REMARKS

Amendments to the Drawings:

FIG. 1

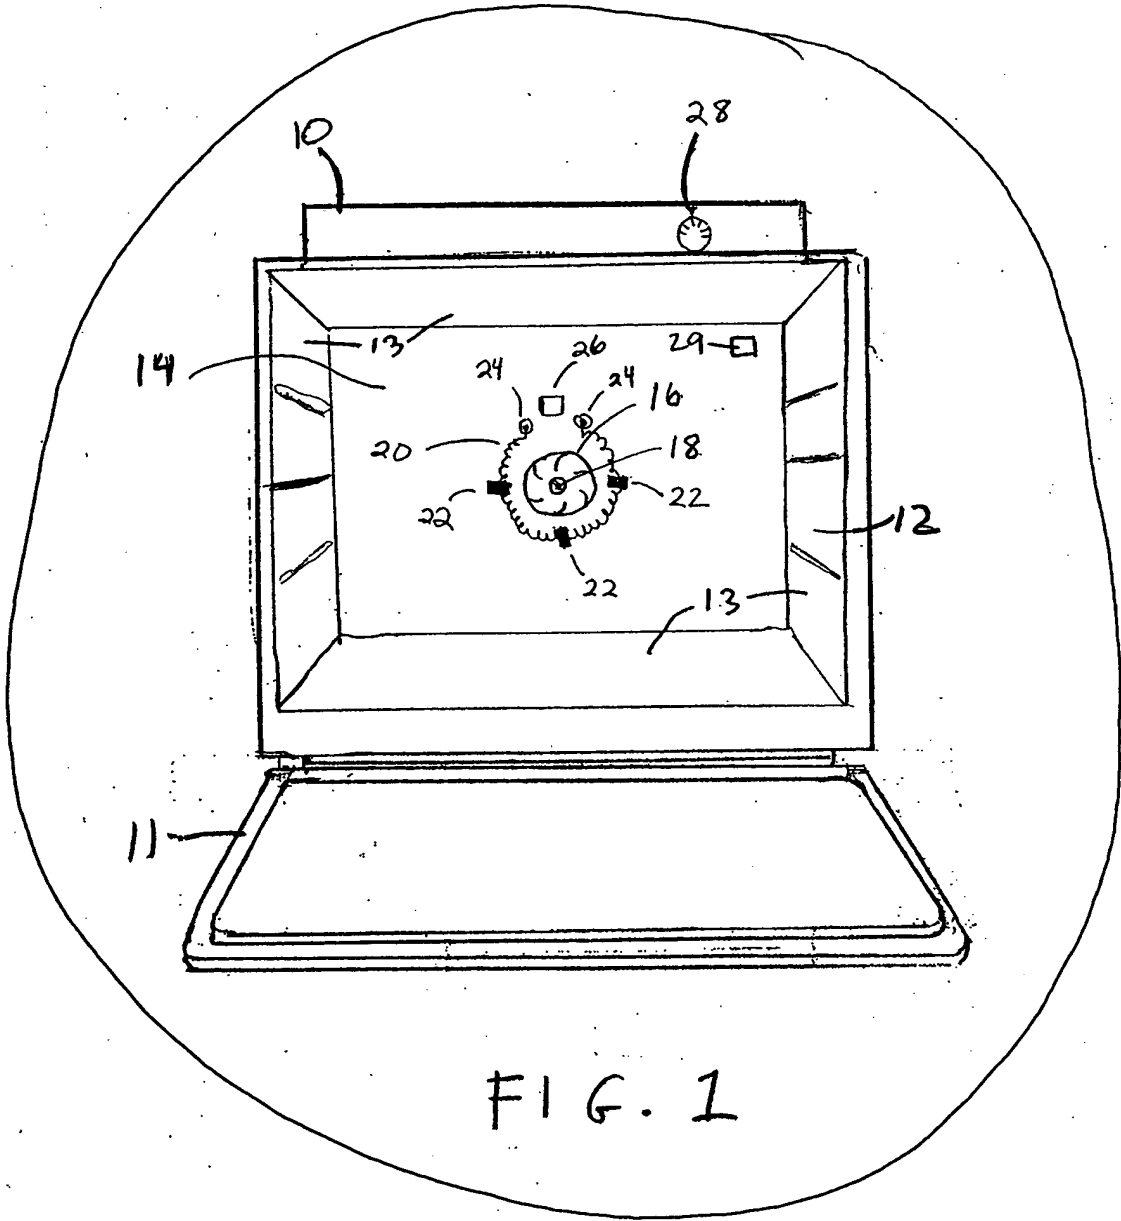
The specific changes which have been made to the new formal drawing Figure 1 are to clean up and clarify the front view of a convection oven with the oven door open (to show an exemplary open coil heating element according to the invention) that was shown in the Figure 1 previously submitted.

Fig. 2

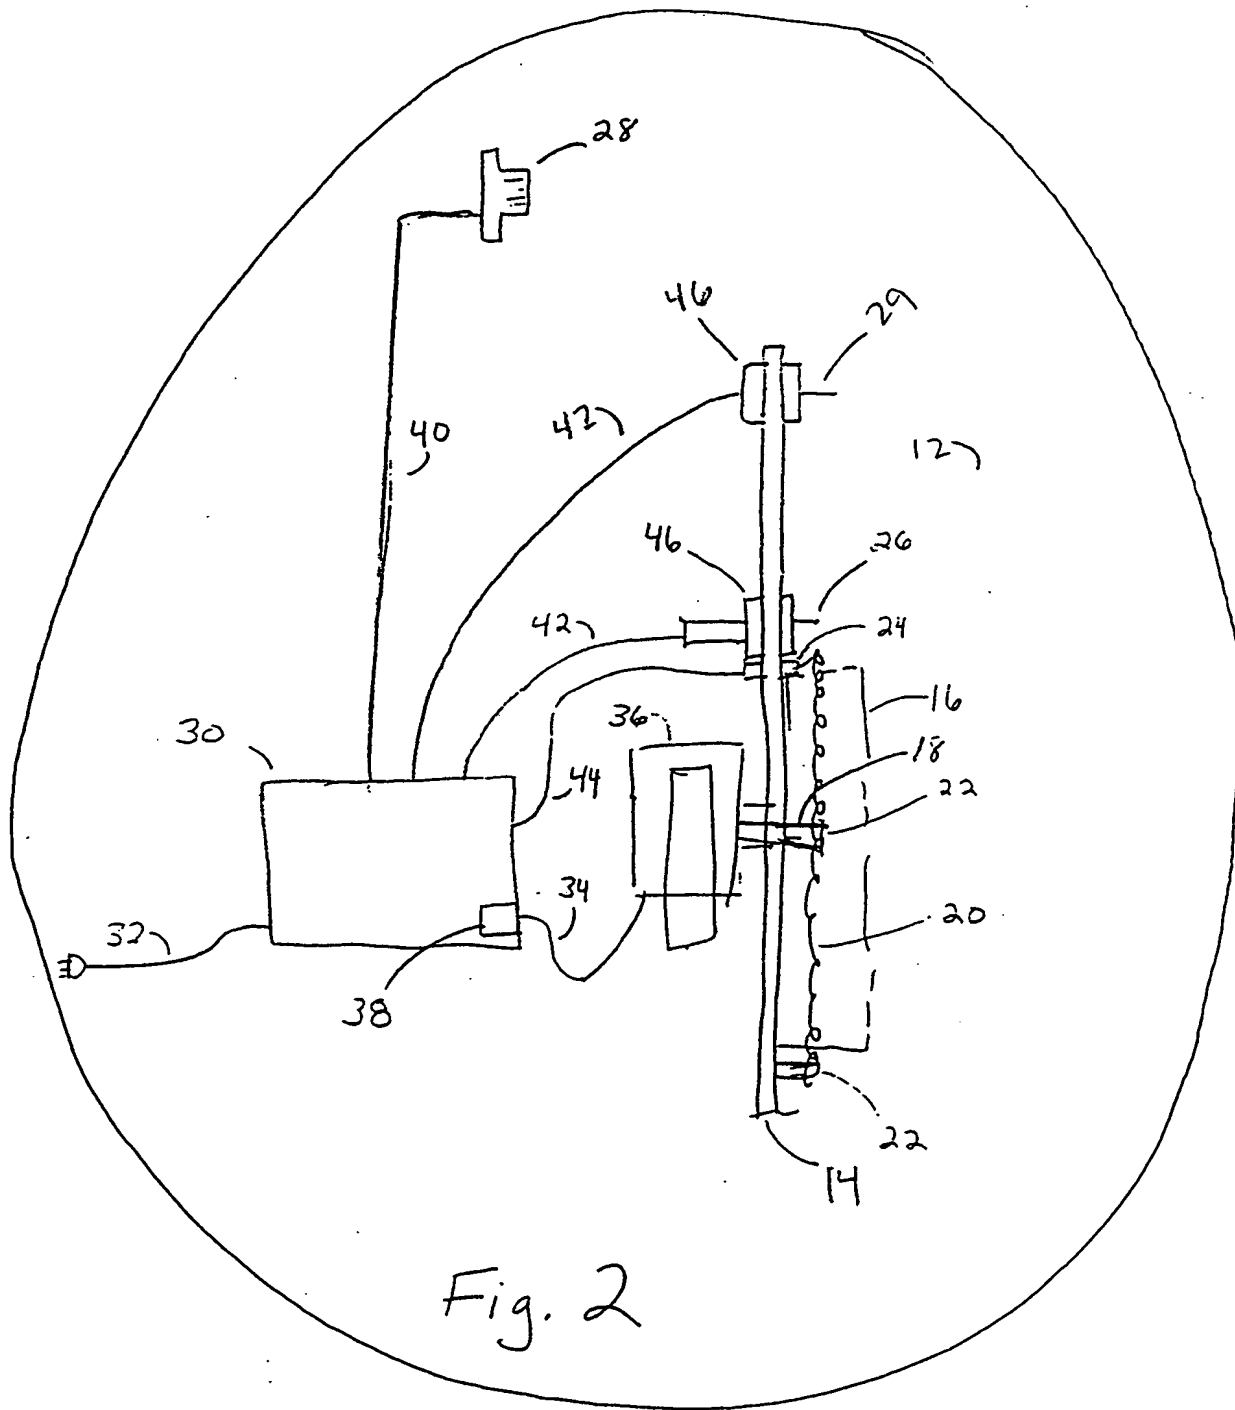
The specific changes which have been made to the new formal drawing Figure 2 are to clean up and clarify the schematic side view block diagram of an exemplary open coil heating element and fan according to the invention that was shown in the Figure 2 previously submitted.
